CAPRICORN MUNICIPAL DEVELOPMENT GUIDELINES

2022 MEETING 02 MINUTES

Date and Time: 3 March 2022 10:00 am

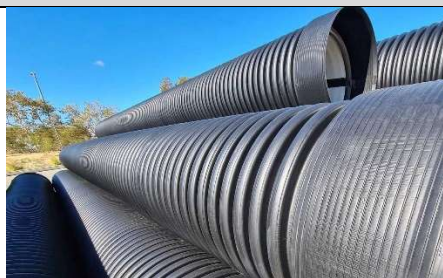
22.02.11	<p>CMDG-S-030 Type C Vertical H.C.</p> <ul style="list-style-type: none"> • <u>RRC Comments from Mohit</u> - CMDG-S-030 Type C Vertical H.C. - Heavy duty fibreglass coated junctions are made from a 45' junction and a 45' bend. This places the property connection directly above the sewer main. A standard (less than 2 metres deep junction is made up from a 45' junction and a 60' bend this offsets the property connection to one side (as it's drawn in CMDG-S-030). Is there any reason the standard connection cannot be directly above the main like a heavy duty junction.

Item	Item	Action By
	 <p>ELEVATION TYPE C VERTICAL H.C. BRANCH FINISHED DETAIL (Vertical drop 2100 and above)</p> <ul style="list-style-type: none"> The standard connection could be above the main but the concrete support under the bend off the main would mean the main would need to be encased in concrete to comply. For discussion – drawing extract above for clarity. <p><u>Resolution</u> General acceptance regarding the use of connections directly above main. Discussion regarding removal of the house drain and Y branch in the Pre Site Development details. Agreement reached that it should be removed. Jamie (RRC) to provide markups to drawing CMDG-S-030 for MCE to complete.</p> <p><u>Action By</u> RRC/ MCE</p>	RRC/ MCE
